# FINAL PLAT

## WILSON FARMS FOURTH ADDITION

RE: SUB 2003-47 -- One-Step Final Plat of Wilson Farms Fourth Addition

**CASE NUMBER:** SUB 2003-47 -- WILSON FARMS FOURTH ADDITION

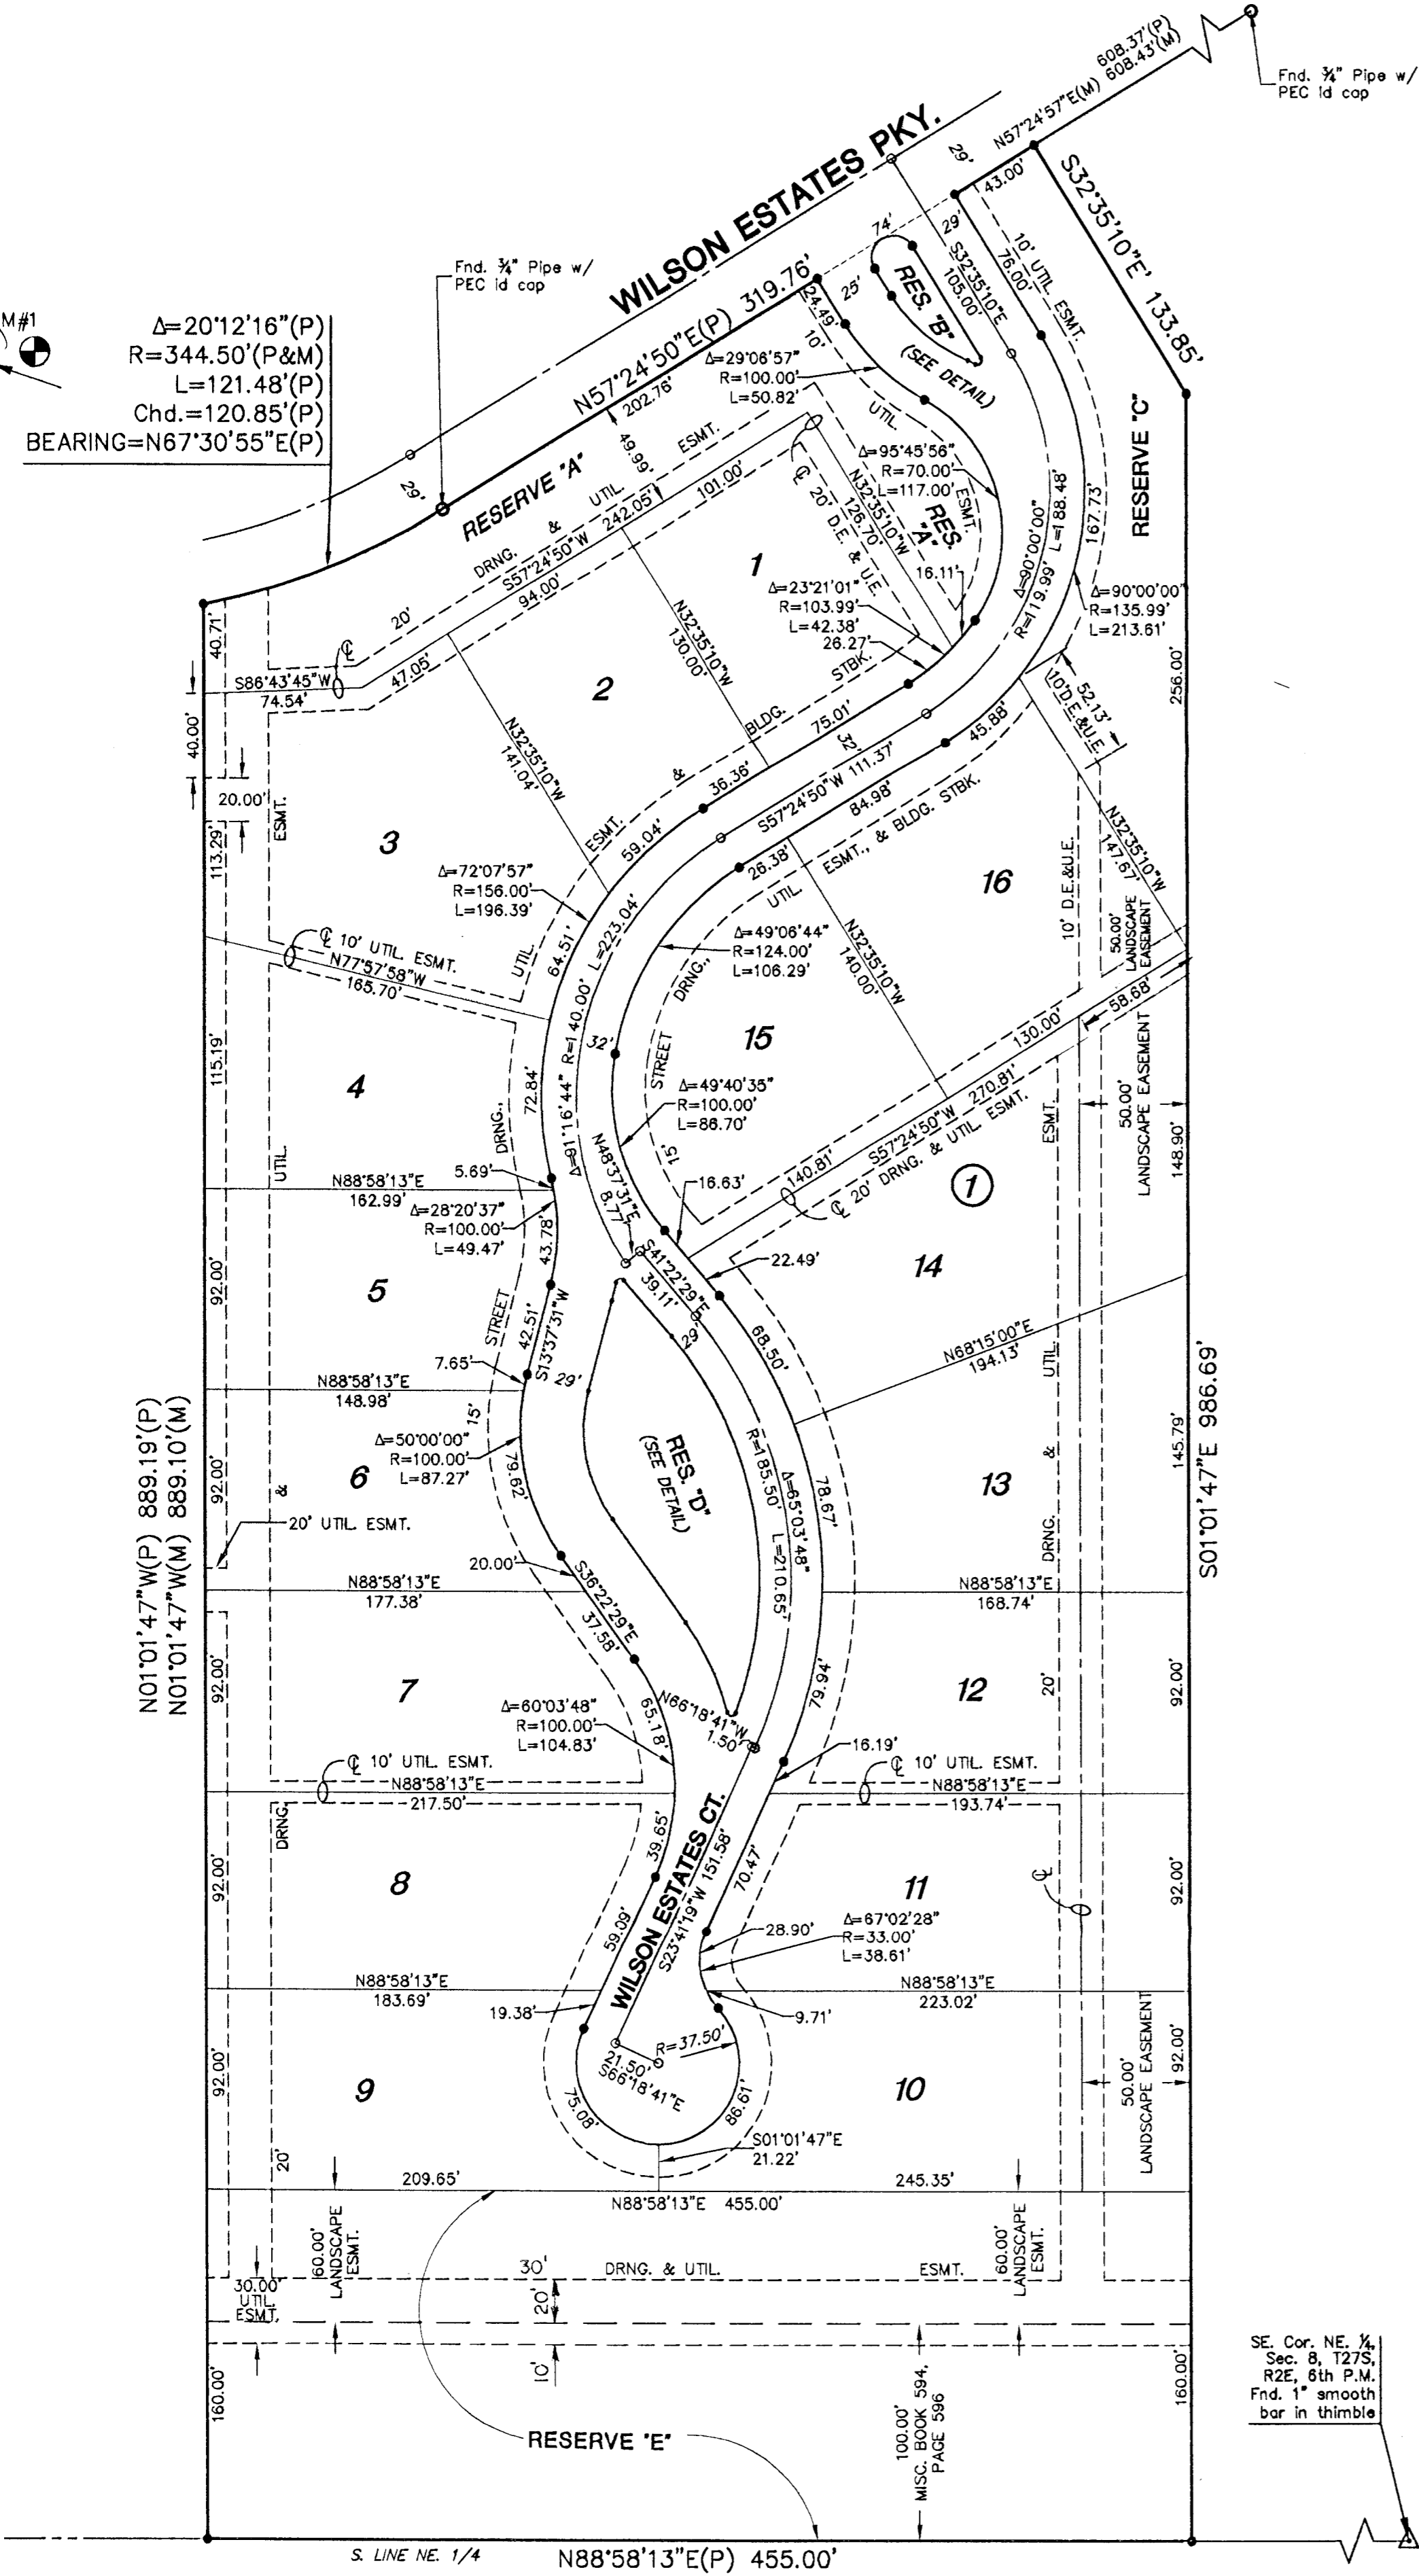
- A. The applicant shall guarantee the extension of sanitary sewer and City water to serve the lots being platted. City Engineering needs to comment on the need for other guarantees or easements. The 20-ft easement within Reserve F needs to be labeled. The easement along the west line of the plat needs to be labeled.

- C. City Engineering needs to comment on the status of the applicant's drainage plan. The drainage plan is approved. An off-site drainage easement is needed.

- D. Traffic Engineering has requested that Reserve D be expanded to include the parking bays currently denoted as street right-of-way.
- E. Traffic Engineering needs to comment on the need for additional right-of-way along the interior street. The plat denotes a 24-ft right-of-way width along portions of the street. The right-of-way width of Wilson Estates Court adjoining Reserve D shall be increased to 29 feet. Yield signs will need to be posted as necessary.

- L. City Fire Department requests the ingress entrance be a 20-ft paved road surface. The egress shall be a 24-ft paved road surface. "No Parking" signs shall be posted.

- M. Since this plat proposes the platting of narrow street right-of-way with adjacent "15-foot street drainage and utility easements", a restrictive covenant shall be submitted which calls out restrictions for lot-owner use of these easements. Retaining walls and change of grade shall be prohibited within these easements as well as fences, earth berms and mass plantings.

- A. The applicant shall guarantee the extension of sanitary sewer and City water to serve the lots being platted. **City Engineering** needs to comment on the need for other guarantees or easements. The 20-ft easement within Reserve F needs to be labeled. The easement along the west line of the plat needs to be labeled.

- C. **City Engineering** needs to comment on the status of the applicant's drainage plan. The drainage plan is approved. An off-site drainage easement is needed.

- D. **Traffic Engineering** has requested that Reserve D be expanded to include the parking bays currently denoted as street right-of-way. *& covenant addressing*

- E. **Traffic Engineering** needs to comment on the need for additional right-of-way along the interior street. The plat denotes a 24-ft right-of-way width along portions of the street. The right-of-way width of Wilson Estates Court adjoining Reserve D shall be increased to 29 feet. Yield signs will need to be posted as necessary.

- L. **City Fire Department** requests the ingress entrance be a 20-ft paved road surface. The egress shall be a 24-ft paved road surface. "No Parking" signs shall be posted.

- M. Since this plat proposes the platting of narrow street right-of-way with adjacent "15-foot street drainage and utility easements", a restrictive covenant shall be submitted which calls out restrictions for lot-owner use of these easements. Retaining walls and change of grade shall be prohibited within these easements as well as fences, earth berms and mass plantings.
